EAST WHITELAND TOWNSHIP – ACT 537 PLAN DOCUMENTS
(SPECIAL STUDY 2011)

“SPECIAL STUDY”

RE: "Special Study" Act 537 Plan Amendment – Response to PADEP Comments
East Whiteland Township / Mill Lane Pumping Station Replacement Project

RE: Act 537 Special Study Amendment – Response #2
East Whiteland Township, Chester County
Mill Lane Pump Station Replacement Project

EAST WHITELAND TOWNSHIP

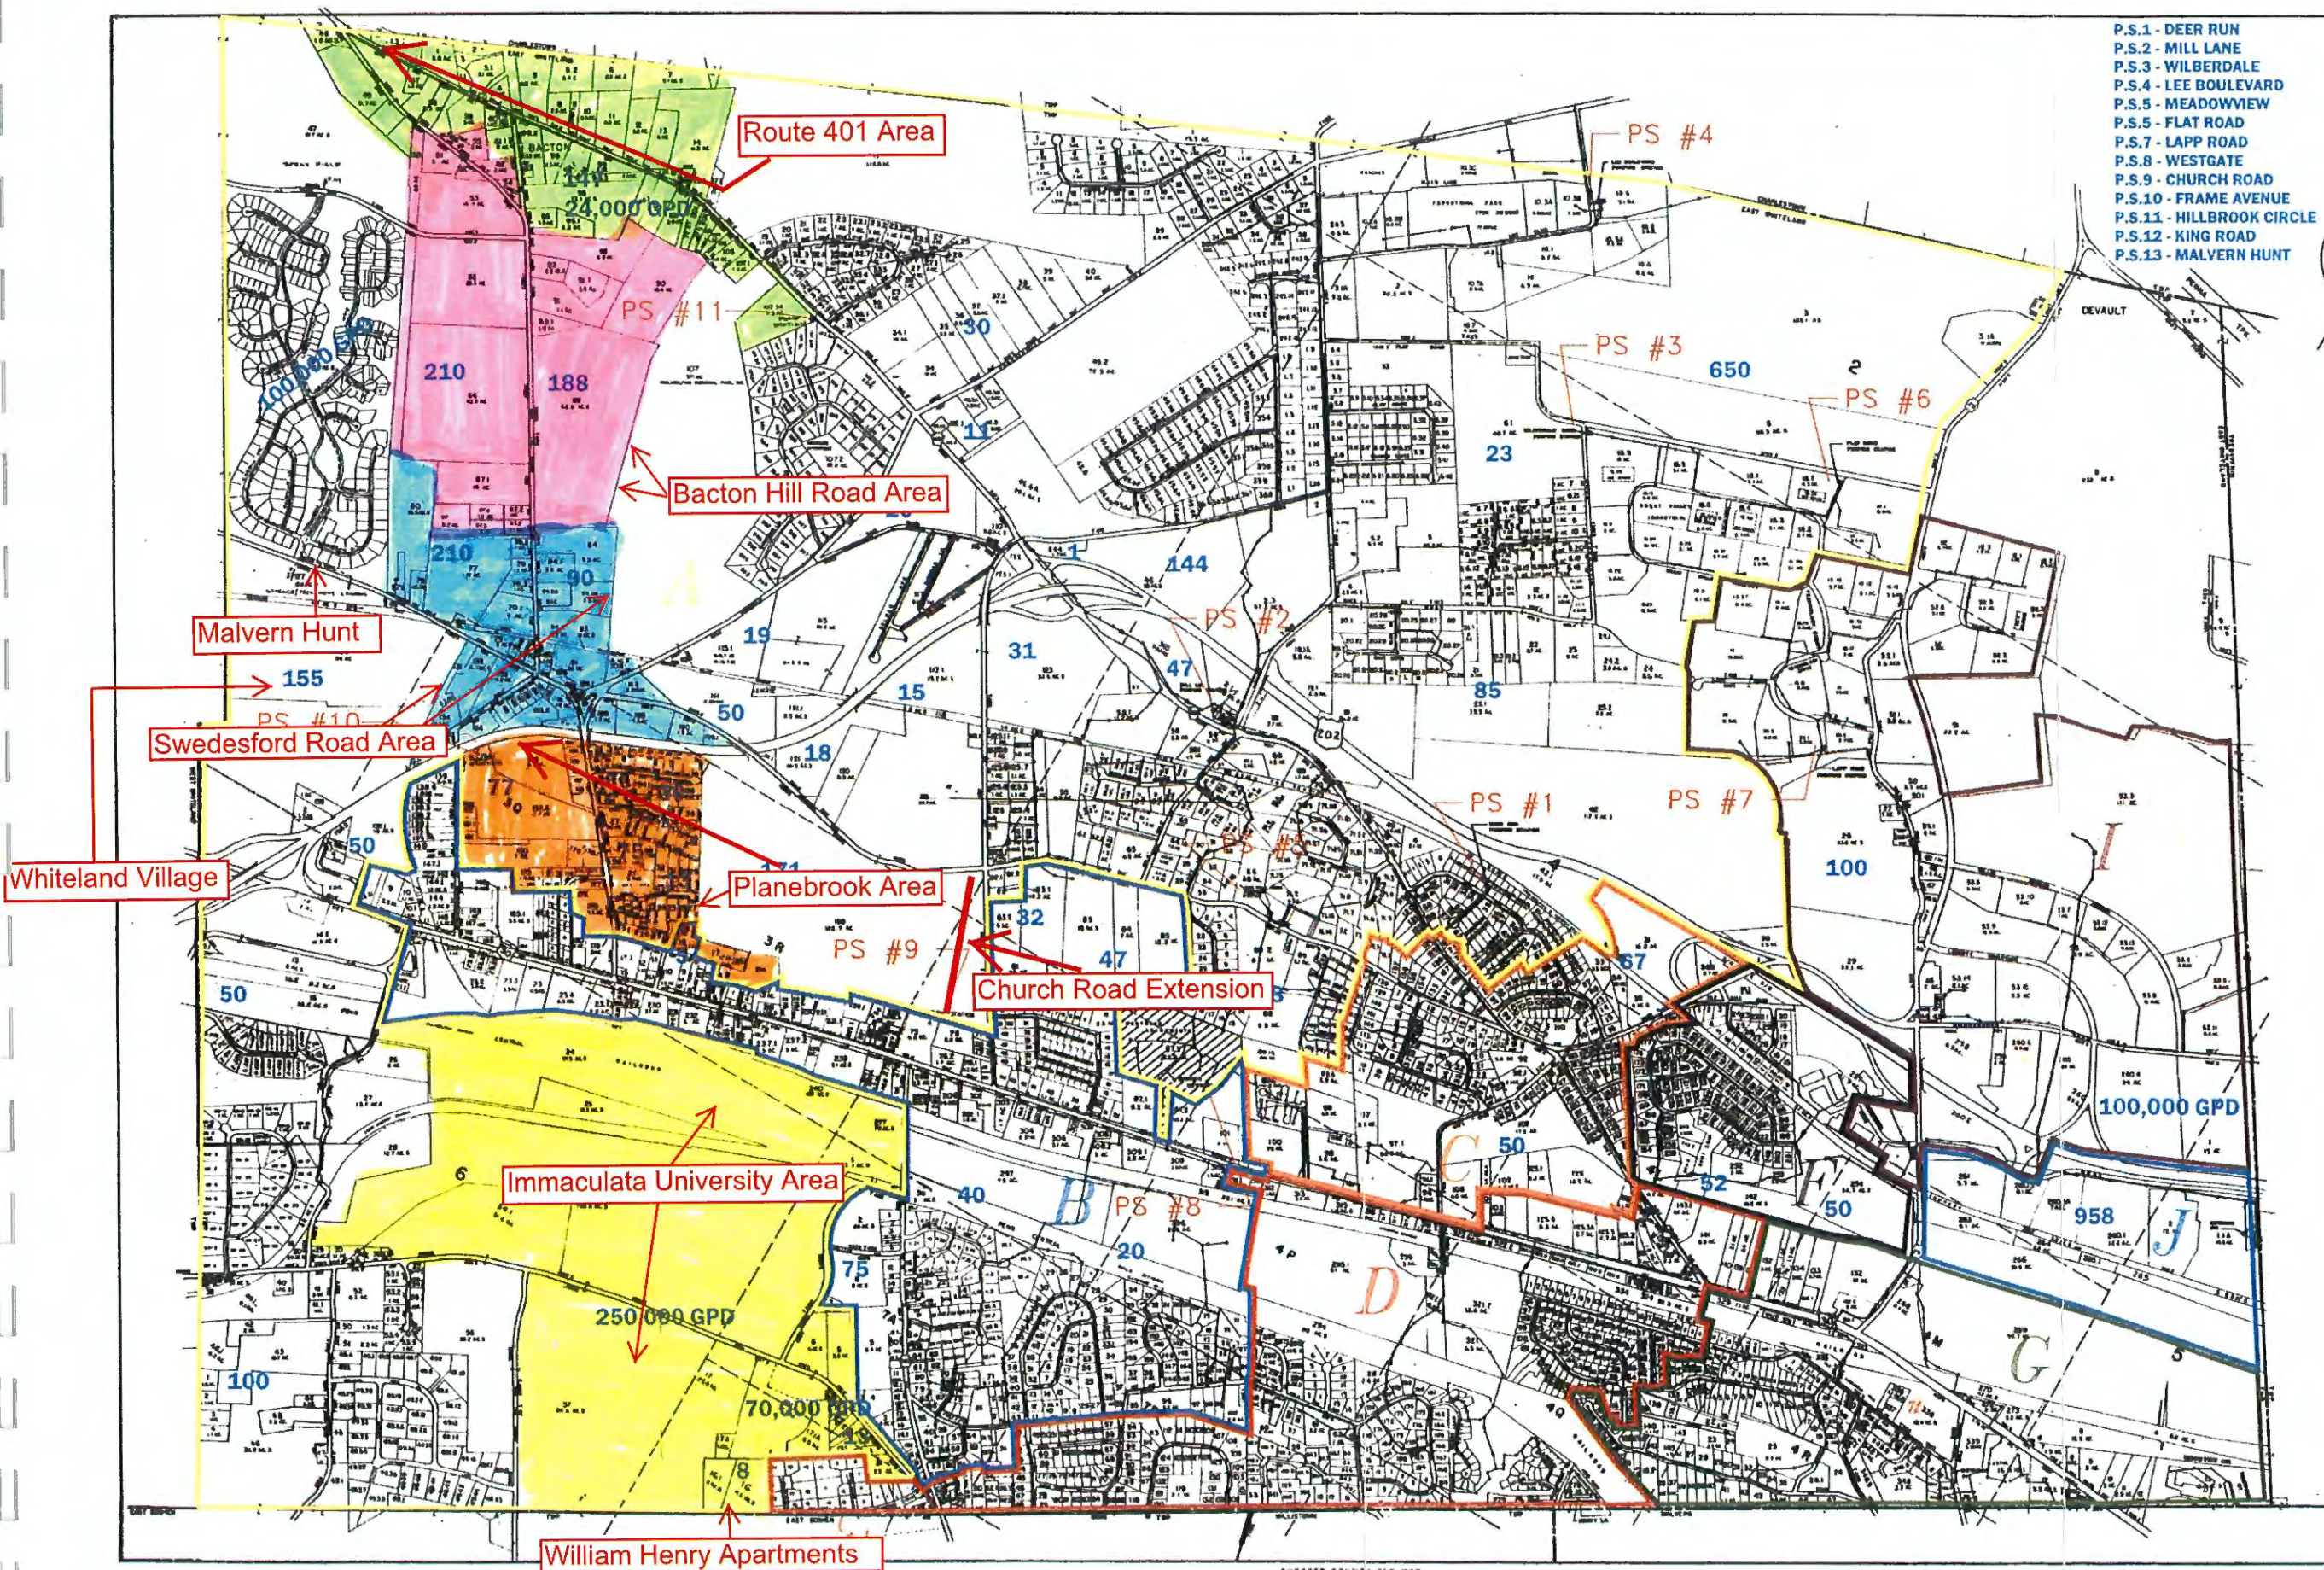
10. Please provide map(s) showing the proposed conceptual extensions in each area as well as the path from the MLPS to Manhole LV77A on the LV trunk sewer. These map(s) should be at a scale large enough to distinguish the detail shown and should also include a map legend.

Refer to attached Exhibit 2; which illustrates the items requested above and all planned improvements per the "Special Study".

FIGURE 4B TABLE
REVISED MUNICIPAL CONNECTION POINTS
PROJECTED FLOWS

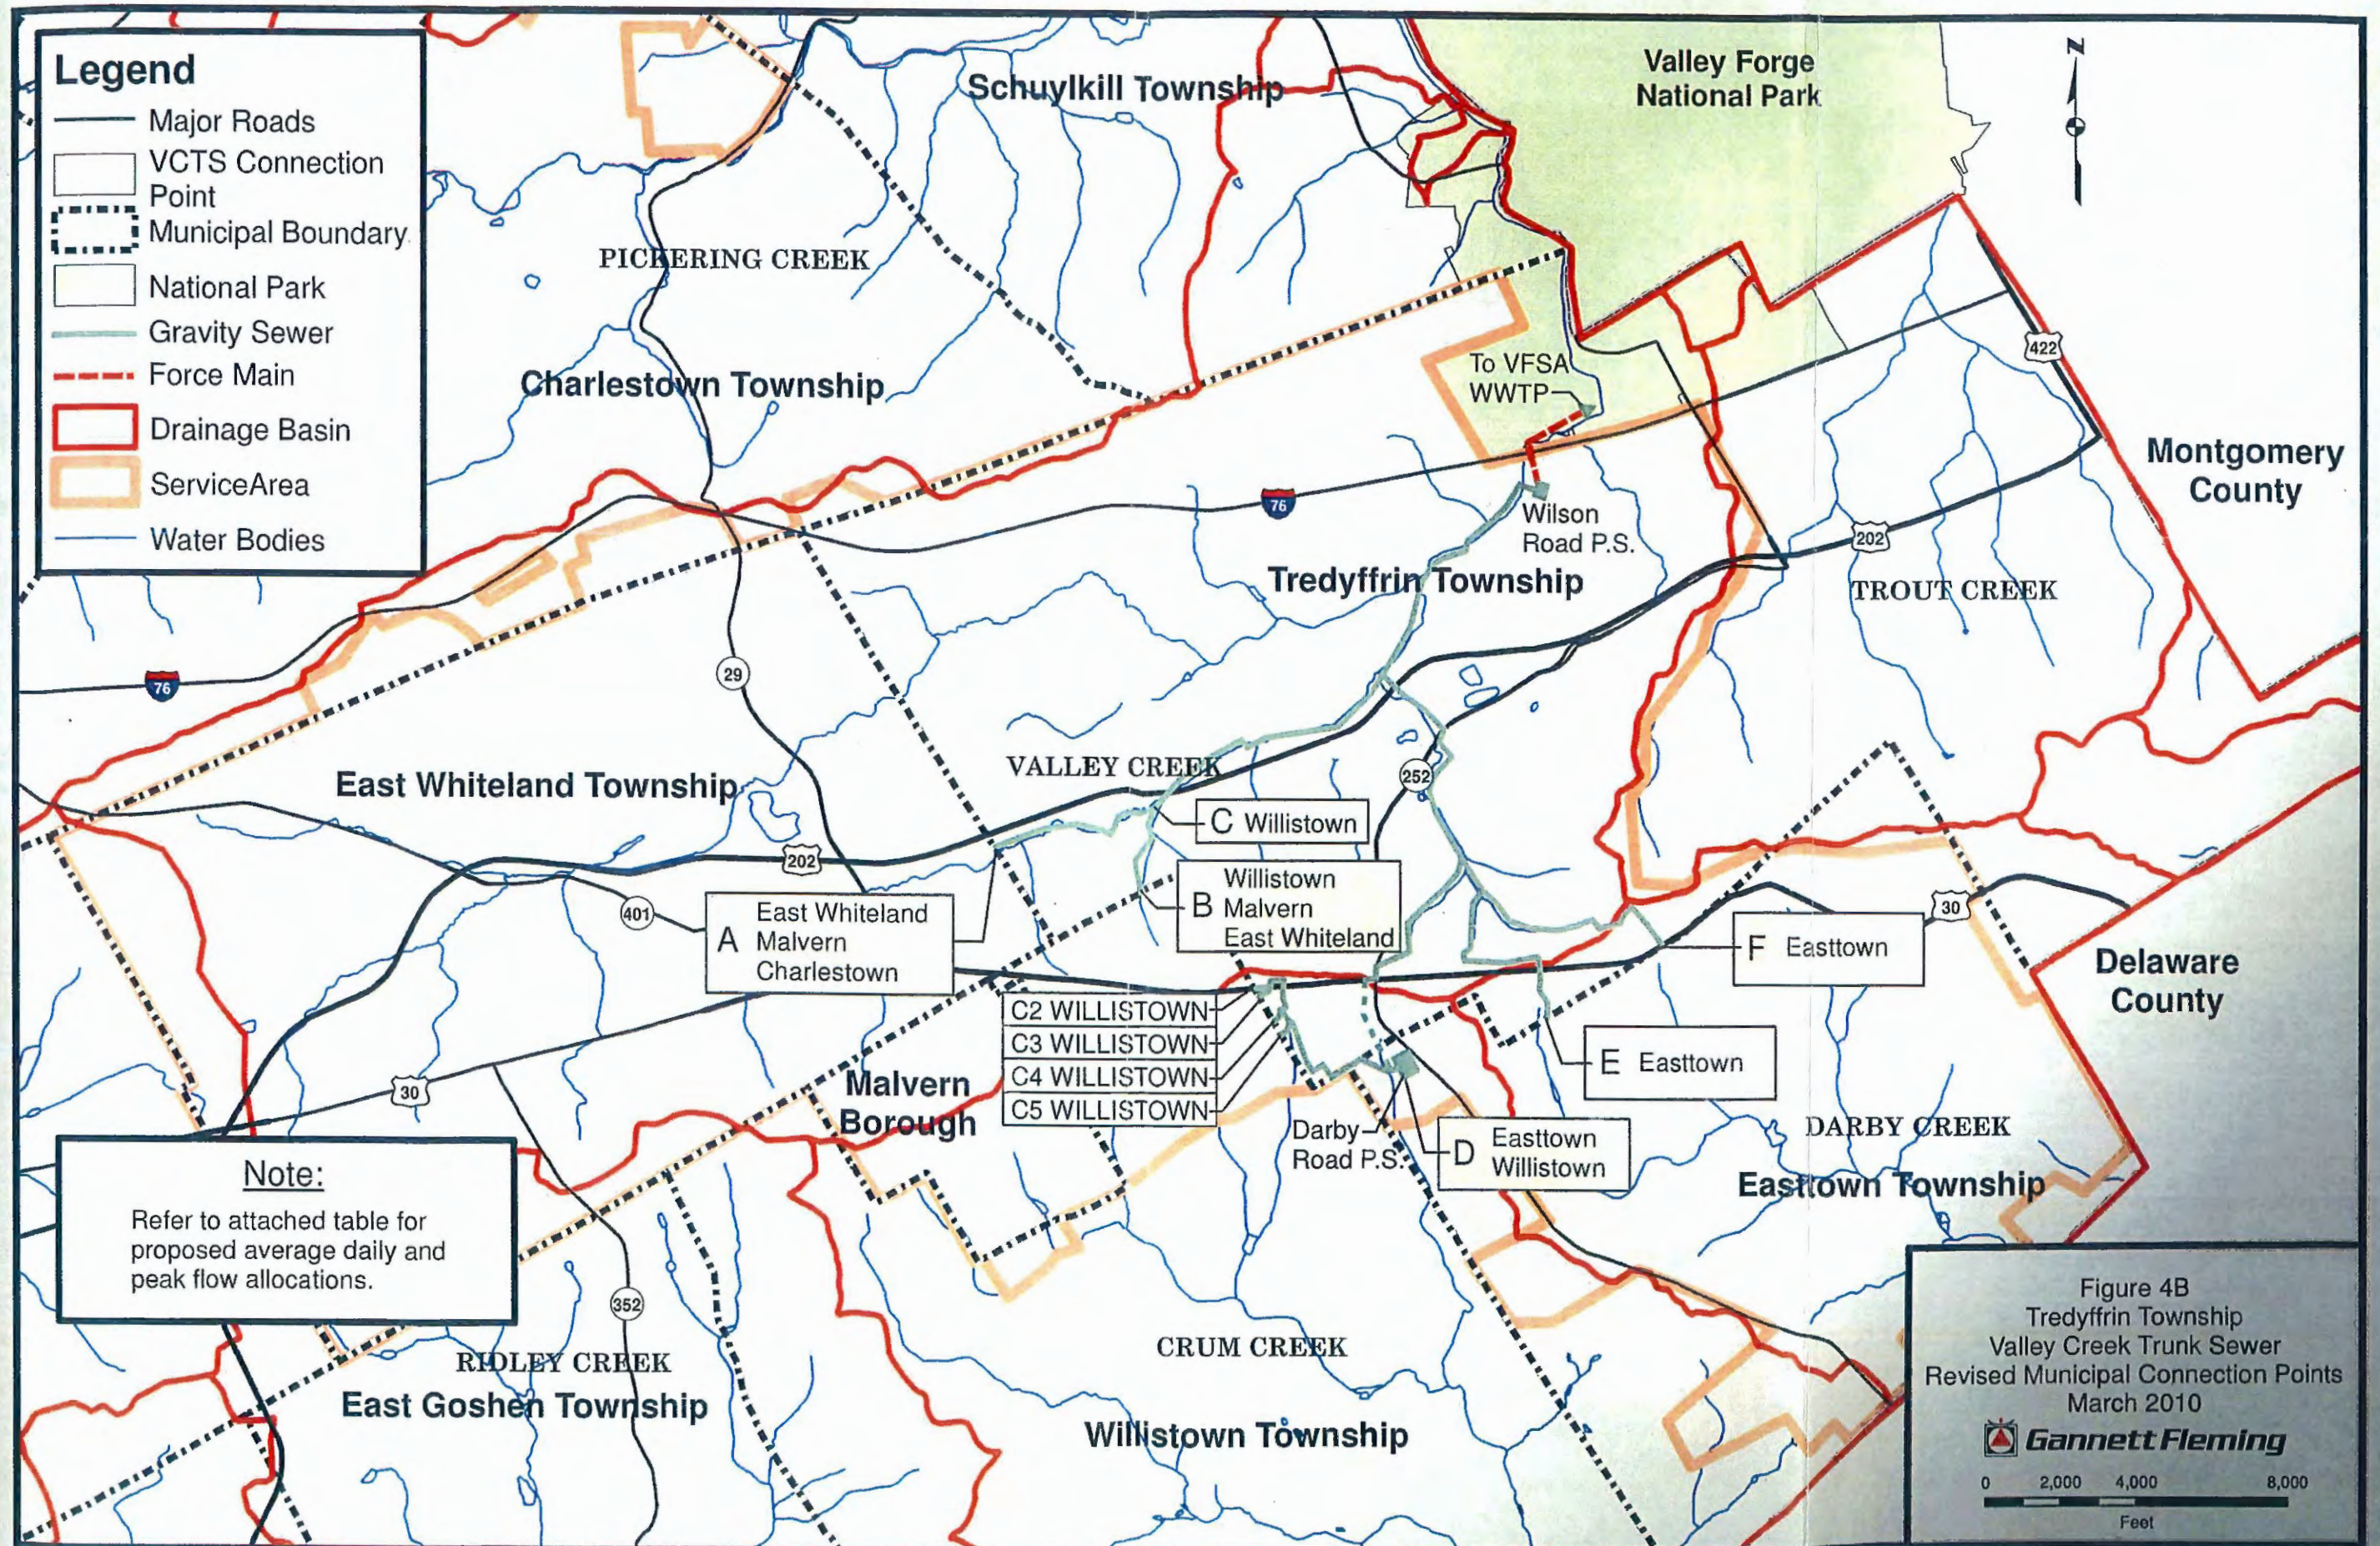
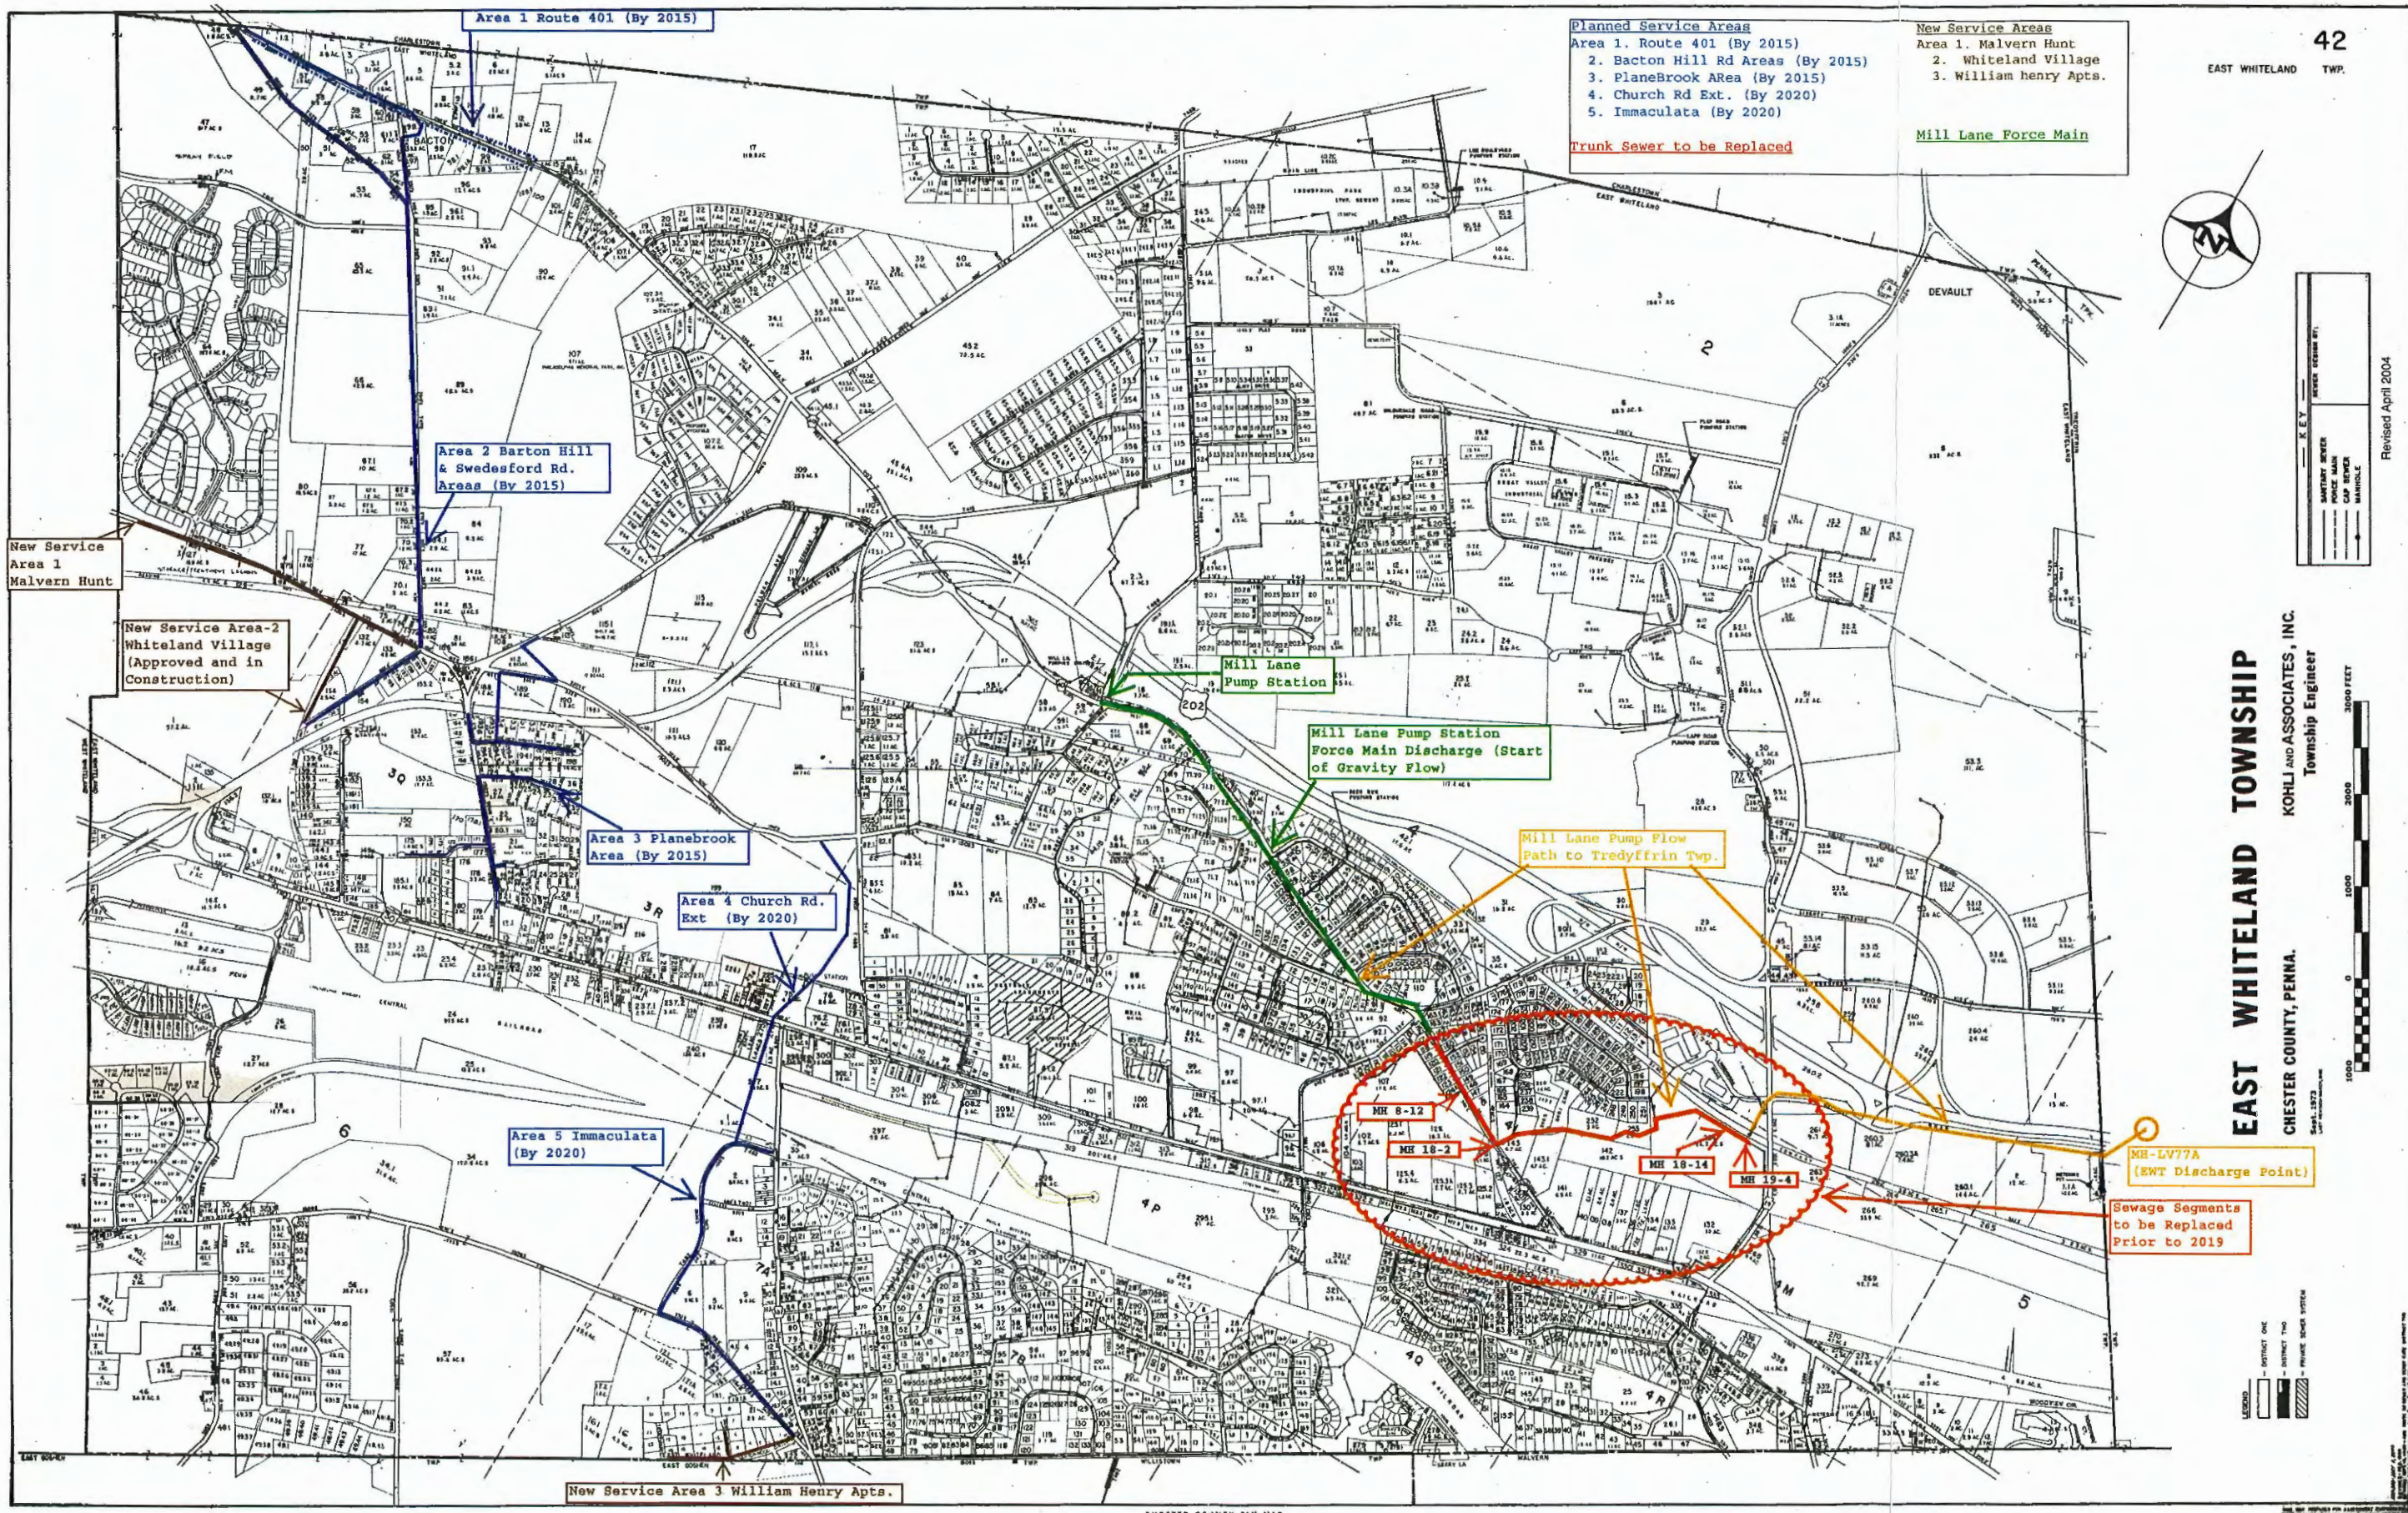
13. The submitted Special Study indicates that the 2035 projected flows for the Township are available in the flow already allocated to the Township from both Tredyffrin Township and the VFSA. Please provide correspondence from both Tredyffrin Township and VFSA confirming this statement.

Attached as Exhibit 3 is a table and figure from Tredyffrin's recent Act 537 Plan Revision for Valley Creek Trunk Sewer dated April of 2010. This correspondence documents the

projected flows for EWT as it pertains to Tredyffrin's the VCTS project improvements. These projected flows coincide with what has been summarized in EWT's Act 537 Plan "Special Study" report.
